World Forum for Harmonization of Vehicle Regulations**Working Party on Automated/Autonomous and Connected Vehicles****Seventh session**

Advanced Emergency Braking Systems**Proposal for Supplement 3 to the original text to
UN Regulation No. 152 (Advanced Emergency Braking
Systems for M₁ and N₁ vehicles)****Submitted by the experts from the Informal Working Group on
Advanced Emergency Braking Systems for vehicles of Categories M₁
and N₁***

Figure 1: left turn or right turn at the intersection

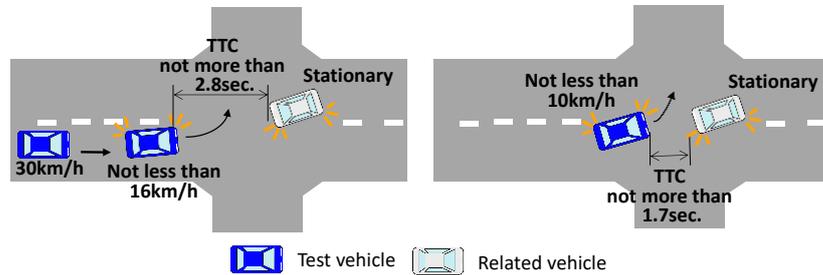
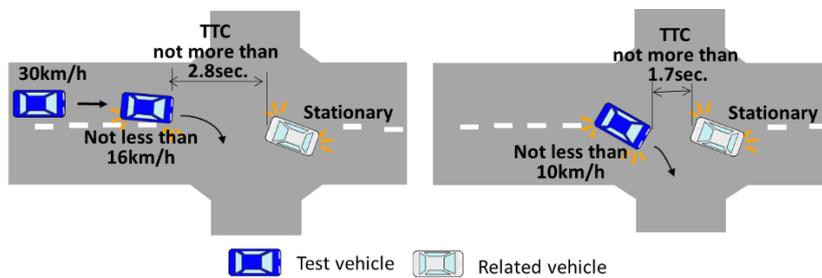
Left turn or Right turn at the intersection

- 1.1. **In this scenario, the subject vehicle passes by a left turn or right turn in front of an oncoming vehicle that is stopped to make a left turn or right turn at an intersection.**
- 1.2. **An example of the detail scenario:**

The subject vehicle drives at a speed of 30 km/h (with a tolerance of +0/-2 km/h) toward the intersection, and decelerates by braking to a speed of not less than 16 km/h at a point where the subject vehicle begins to steer left / right, and the Time To Collision (TTC) to the oncoming vehicle is not more than 2.8 seconds. When the subject vehicle turns left or right in the intersection, the speed is reduced to not less than 10 km/h, and then drives at a constant speed. The TTC to the oncoming vehicle is not more than 1.7

seconds at when the wrap ratio between the subject vehicle and the oncoming vehicle becomes 0 per cent.

Figure 2: right turn or left turn of a forward vehicle

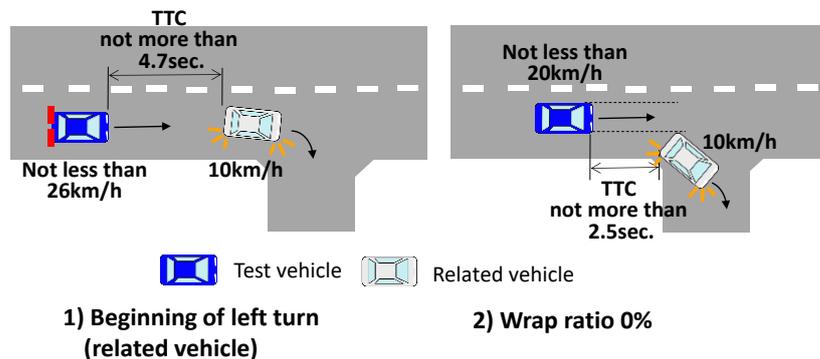
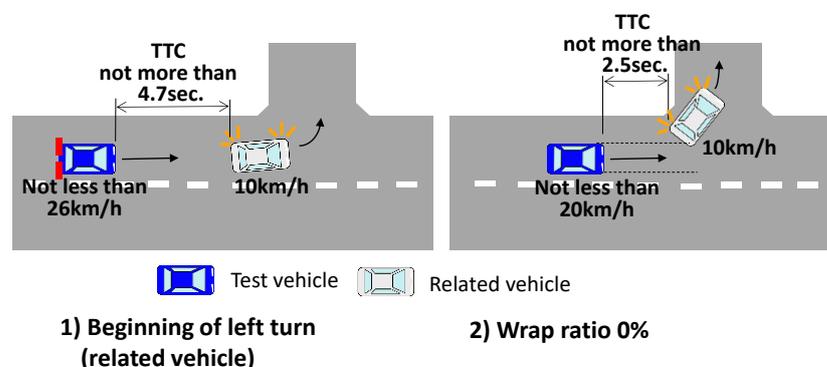
Right turn or Left turn of a forward vehicle

- 2.1. In this scenario, the subject vehicle follows a forward vehicle. After that, the forward vehicle turns right or left at a corner, and the subject vehicle goes straight.
- 2.2. An example of the detail scenario:

Both the forward vehicle and the subject vehicle drive at a speed of 40 km/h (with a tolerance of +0/-2 km/h) on the straight road. The forward vehicle decelerates by braking to a speed of 10 km/h (with a tolerance of +0/-2 km/h) in order to turn right or left at the corner, and the subject vehicle also decelerates by braking to keep appropriate distance with the forward vehicle. At when the forward vehicle begins to turn right or left, the speed of the subject vehicle is not less than 26 km/h and the TTC to the frontal vehicle is not more than 4.7 seconds. After that, the subject vehicle decelerates to a speed of not less than 20 km/h, and then drives at a constant speed. The TTC to the forward vehicle is not more than 2.5 seconds at when the wrap ratio between the subject vehicle and the forward vehicle becomes 0 per cent.

Figure 3: curved road with guard pipes and a stationary object

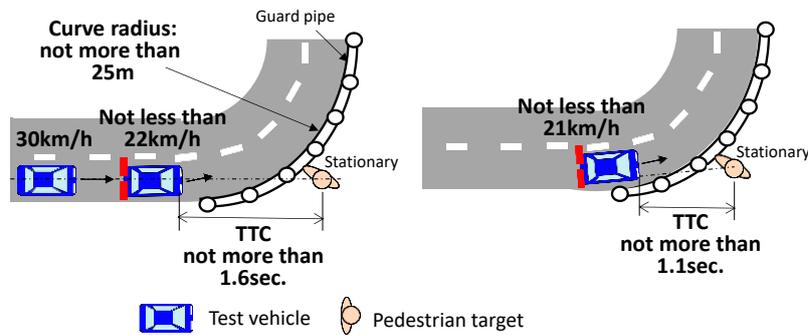
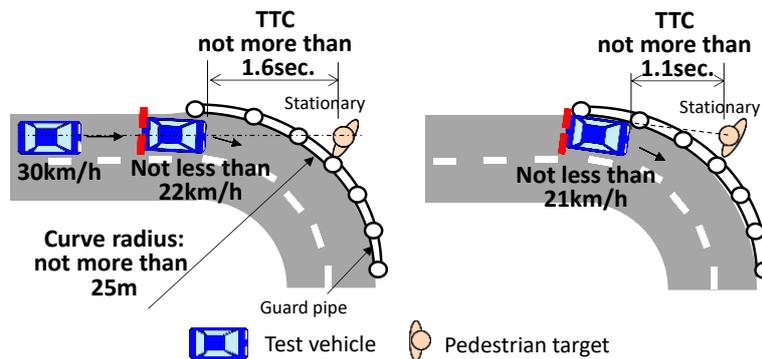
Curved road with guard pipes and a stationary object

3.1. In this scenario, the subject vehicle drives a small radius curved road of which the guard pipes are constructed to the outer side, and a stationary vehicle (M₁ category), a stationary pedestrian target or a stationary bicycle target is positioned just outside of the guard pipes and where on the extension of the centre of the lane.

3.2. An example of the detail scenario:

The subject vehicle drives at a speed of 30 (with a tolerance of +0/-2 km/h) km/h toward the curve of which the radius is not more than 25 m at the outer side of the road, and decelerates by braking to a speed of not less than 22 km/h at a point where the subject vehicle enters the curve. The TTC to the stationary object is not more than 1.6 seconds at when the subject vehicle begins to turn in the curve. In the curve, the subject vehicle drives outer lane than the centre of the road. After that, the subject vehicle continue to turn in the curve at a constant speed of not less than 21 km/h. The TTC to the stationary object is not more than 1.1 second at when the wrap ratio between the subject vehicle and the stationary vehicle becomes 0%, or at when the offset ratio between the subject vehicle and the centre of the stationary pedestrian target or the stationary bicycle target becomes -100%.

Figure 4: lane change due to road construction

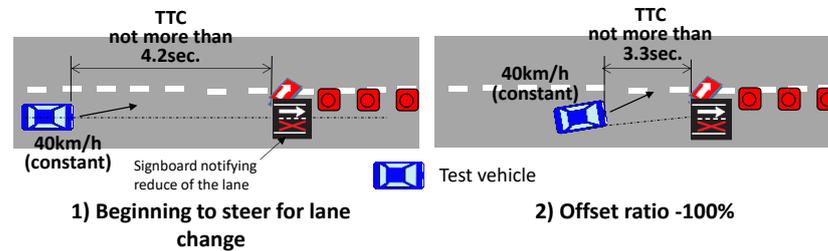
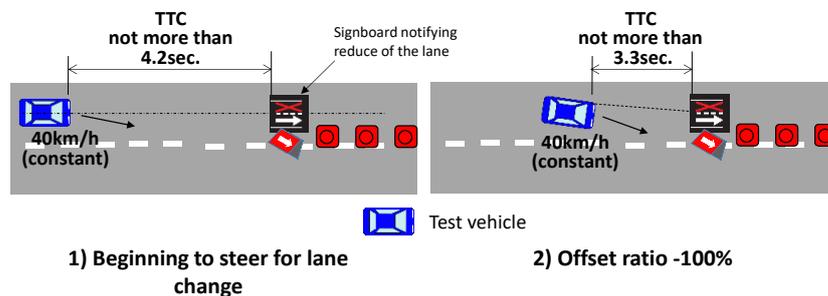
Lane change due to road construction

- 4.1. In this scenario, the subject vehicle changes the lane in front of the signboard which is positioned in the centre of the lane and notifies the driver that the lane is reduced.
- 4.2. An example of the detail scenario:

The subject vehicle drives a straight road at a speed of 40 km/h (with a tolerance of +0/-2 km/h), and begins to steer in order to change the lane in front of the signboard which notifies reducing the lane. No other vehicles approach the subject vehicle. The TTC to the signboard is not more than 4.2 seconds at when the subject vehicle begins to steer. During changing the lane, the speed of the subject vehicle is constant, and the TTC to the

signboard is not more than 3.3 seconds at when the offset ratio between the subject vehicle and the centre of the signboard becomes -100 per cent.
